REVISIONS		
REV	SH	ZN
NO		
DESCRIPTION		
RESERVATIONS		
UNIT: CDR: B029		
DISTRIBUTION STATEMENT		
APPROVED FOR PUBLIC RELEASE. DISTRIBUTION IS UNLIMITED.		
THIS DWG INCORPORATES THE FOLLOWING CHANGE ORDERS		
HMR	HMR	HMR
FMR	FMR	FMR
2376 T-AKR 303 2496 T-AKR 306		
2375 T-AKR 302 2378 T-AKR 305		
2374 T-AKR 301 2377 T-AKR 304		
2373 T-AKR 300 2377 T-AKR 304		
AVONDALE NO. AVONDALE VESSEL		
AVONDALE JOB NO. C3-222		
A Avondale		
P. O. BOX 50280 NEW ORLEANS, LA 70150-0280 CAGE 1CC97		
CONTRACT NUMBER N00024-93-C-2205		
DRAWN DATE 4/21/94		
CHECKED		
JN 4/21/94		
APVD C3-222		
DLP 4/22/94		
APVD 94421 COMSC 802-6976055		
BJG 4/22/94		
SCALE 1/16"=1'-0" SH NO 1 OF 1

NOTE: SEE DWG NO C3-222, 01-03-01 FOR GENERAL NOTES, ABBREVIATIONS AND SYMBOL LIST.

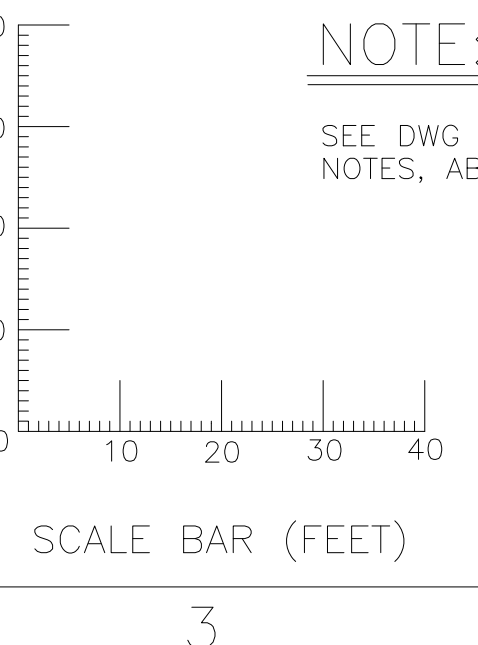
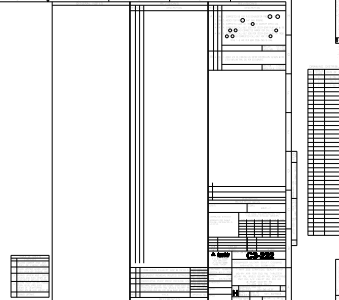
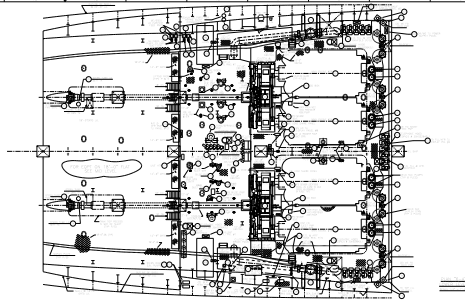
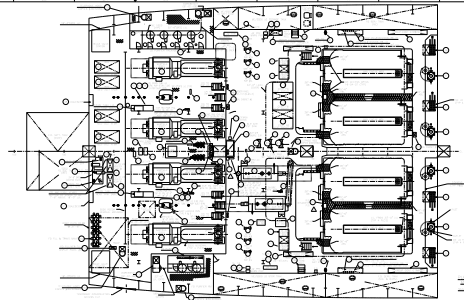
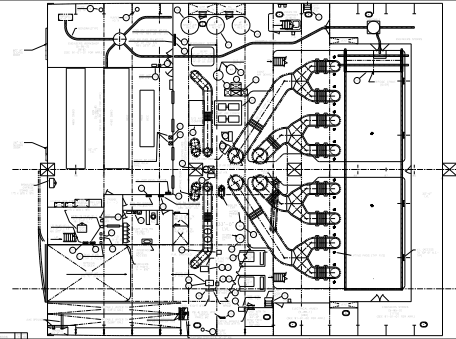
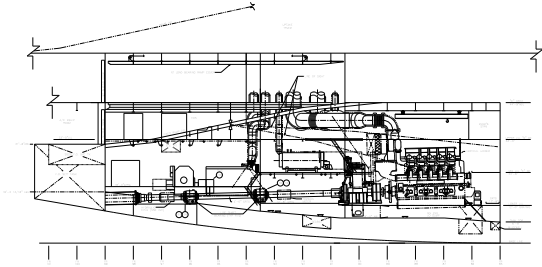
REVISIONS			REVISIONS		
REV	SH	ZN	REV	SH	ZN
A			A		
11-C	VAR	11. GENERALLY REVISED TO UPDATE DRAWING WITH C & A DRAWINGS.	1-A	VAR	1. MODIFIED HVAC DUCTS @ SHELL TO SUIT DEVELOPMENT.
12-C	VAR	12. VERIFIED LOCATION AND REVISED CALLOUT OF DOOR LOCATED ON "D" DECK RAMP TO READ "FIRE DOOR" TO CORRECT.	2-A	VAR	2. DELETED VENT TRUNKS @ BHD 20.
13-F	VAR	13. UPDATED RAMP DECK CUTS TO SUIT STRUCTURAL DEV.	3-A	VAR	3. DELETED FAN RM @ FR 33.
14-C	VAR	14. INDICATED WIREWAYS WITH APPROPRIATE DECK PENETRATIONS AT INBD SIDE OF STARTOWER, FR 97 TO 98, STBD TO SUIT.	4-A	VAR	4. DELETED FAN RM & ADDED STARTOWER AFT FR 50.
15-C	VAR	15. ADDED RUDDER HORN BRACKETS TO SUIT.	5-A	VAR	5. DELETED STARTOWERS & VENT TRUNKS @ FR 71.
16-C	VAR	16. REVISED LOCATION OF STEERING GEAR RM DOORS P/S.	6-A	VAR	6. ADDED STARTOWER @ FR 85.
17-C	VAR	17. ADDED VL PORT SIDE OF STEERING GEAR RM.	7-A	VAR	7. DELETED VENTS @ FR 113.
18-G	VAR	18. RELOCATED VL IN STEERING GEAR RM AND INDICATED SCUTTLE OVER.	8-A	VAR	8. DELETED VENT TRUNKS @ BHD 20.

BY:EM 6/21/95 APVD:BLP 6/26/95			9-A	VAR	9. DELETED WL & VENT TRUNKS @ FR 33.
C			10-A	VAR	10. DELETED VENT TRUNKS & ADDED STARTOWER AFT OF FR 50.
1. VAR	1. UPDATED VENTILATION ARRGT TO SUIT STRUCTURAL DEV.		11-C	VAR	11. DELETED STARTOWERS & VENT TRUNKS & RELOCATED DC LKR @ FR 71.

2. VAR	2. VERTICAL LADDERS IN ALL STARTOWERS DELETED TO SUIT FMR 67.		12-G	VAR	12. DELETED ESCAPE TRUNK @ FR 50 ON "C" & "D" DECK.
3-C	3. RECLASSIFIED RAMP DOORS TO SUIT DEVELOPMENT.		13-G	VAR	13. RELOCATED ESCAPE TRUNKS FROM FR 85 TO FR 71 ON "C" & "D" DECK.
4-C	4. INDICATED UNDER DK BKT ON STANCHIONS AT FR 56 & 65 ON "C" & "D" DK ARRANGEMENTS.		14-G	VAR	14. RELOCATED PORT SLIDING DOOR @ FR 85. WAS FWD OF FRAM.
5-G	5. REVISED SWING OF DOOR IN ESCAPE TRK, FR 99 TO 100, PORT SIDE, TO CORRECT.		15-G	VAR	15. DELETED COLUMN @ FR 62 FROM "C" & "D" DECK.
6-C	6. REVISED CORL NO. IN TITLE BLOCK TO CORRECT.		16-G	VAR	16. RELOCATED COLUMN FROM FWD FR 65 TO AFT FR 65 ON "C" & "D" DECK.
7-C	7. "C" DECK LABELED FOREPEAK TO SUIT.		17-G	VAR	17. ADDED STRUCTURE BETWEEN FR 109 - 113 ON "D" DECK TO SUIT DEVELOPMENT.
8-B	8. GENERALLY UPDATED DRAWING TO SUIT DEVELOPMENT.		18-G	VAR	18. DELETED 8'X8' BERP FROM STBD SIDE. ADDED 7' X 6' BERP TO PORT SIDE.

ITEMS #5 & 7 TO SUIT ODR 2205-250.6-016.2, DATED AUG. 22, 1995.			19-G	VAR	19. ADDED GENERAL NOTE, ABBREVIATION AND SYMBOL JUST NOTE.
BY:EM 5/28/97 APVD:BN 6/4/97			20-G	VAR	20. ADDED SCALE BAR.
D			21-G	VAR	21. INDICATED VERTICAL LADDERS IN CARGO HOLD STARTOWERS.

1. VAR	1. UPDATED ALL MECH PROTECTION TO SUIT OUTFITTING DEV.		22-G	VAR	22. ADDED VERT LADDER FROM "C" DECK TO "B" DECK AT BHD 113.
1-B	1-B 2. EXTENDED DWG. APPLICABILITY TO INCLUDE T-AKR 305.		23-G	VAR	23. UPDATED ENGINE ROOM ARRANGEMENT TO SUIT DEV.
BY:AR 9/15/98 APVD:BN 9/16/98			24-G	VAR	24. REVISED STARTOWER AFT FR 50 AT "C" AND "D" DECKS TO SUIT STRUCTURAL DEVELOPMENT.
E			25-G	VAR	25. RELOCATED HATCH AT AFT SIDE FR 23 FROM STBD SIDE TO PORT SIDE TO SUIT DEVELOPMENT.
1-B	1. EXTENDED DWG. APPLICABILITY TO INCLUDE T-AKR 306.		26-G	VAR	26. DELETED ESCAPE TRUNKS AT FWD AND AFT SIDE OF VERT COLUMN, FR 35 TO SUIT DEVELOPMENT.
BY:AR 11/11/99 APVD:BN 11/11/99			27-G	VAR	27. REVISED SIZE OF AT DOOR, PORT SIDE, BTWN FR 55 & 56 FROM 13'X18' TO 11'X18' TO SUIT DEV.
B			28-G	VAR	28. INDICATED AIR HANDLING UNITS (AHU) TO SUIT DEV.
12-C	1. MODIFIED STARTOWER/ESCAPE TRUNK AT FR 90 PORT AT "D" DECK TO SUIT DEVELOPMENT.		29-G	VAR	29. DELETED ELEVATOR DOOR AT "C" DECK TO ELIMINATE ELEVATOR STOP AT CARGO HOLD AS PER REVISED SPECIFICATIONS.

VAR	2. REVISED ESCAPE TRUNK @ FR 99 TO SUIT DEV.		BY:EM 8/11/94 APVD:BLP 8/12/94		
VAR	3. "C" DECK CHD RAISED WT HATCH PORT SIDE, FR 106 TO FLUSH WT SCUTTLE TO CORRECT AND MOVED SCUTTLE TO FWD SIDE OF FR 106 TO SUIT VENT DEV.		CONTINUED IN NEXT COLUMN		
4-C	4. UPDATED STARTOWER AT FR 24, "D" DECK AND AT FR 112, "C" DECK TO SUIT OUTFITTING DEV.				
14-F	5. CHD HATCHWAY AT FWD SIDE FR 33, PORT TO A SCUTTLE AND RELOCATED TO 14'-0" OFF CL IN LIEU OF 17'-10" OFF CL.				
8-C	6. CHD HATCHWAY AT FWD SIDE FR 33, PORT TO A SCUTTLE AND RELOCATED TO 14'-0" OFF CL IN LIEU OF 17'-10" OFF CL.				
6-C	7. CHD EXTENT OF LONG RAMP BHD, PORT FROM FR 66.5 TO FR 66 TO SUIT STRUCTURAL DEV.				
9-G	8. CHD LOCATION OF DOOR BETWEEN RAMP TO SUIT STRUCTURAL DEVELOPMENT.				
8-C	9. RELOCATED PORT BHD OF STARTOWER TO ALIGN WITH EDGE OF STANCHION & RELOCATED DOOR TO SUIT, ALL TO SUIT DEVELOPMENT.				
11-F	10. FLIPPED ALL STIFFENERS ON BHD 33 TO FWD SIDE AND ALL STIFFENERS ON BHD 99 TO THE AFT SIDE TO SUIT STRUCTURAL DEVELOPMENT.
